Revised Installation from drain line flow control to drain saddle

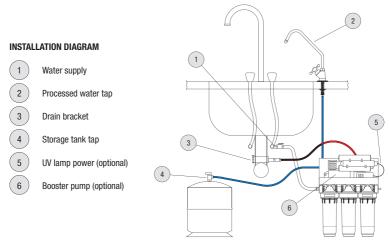
A reducing union connection is now included that will be used to make the connection from the 300 cc ¼" flow control to the 3/8" drain saddle.

When connecting the drain line flow to the drain bracket (#3 on the diagram below) you will use 1 foot of the RED ¼" tubing and connect the reducing union.

On the 3/8" of the union you will connect the 3/8" **BLACK** tubing then run to the drain saddle.

The reason for this change is for adding an optional air gap faucet .
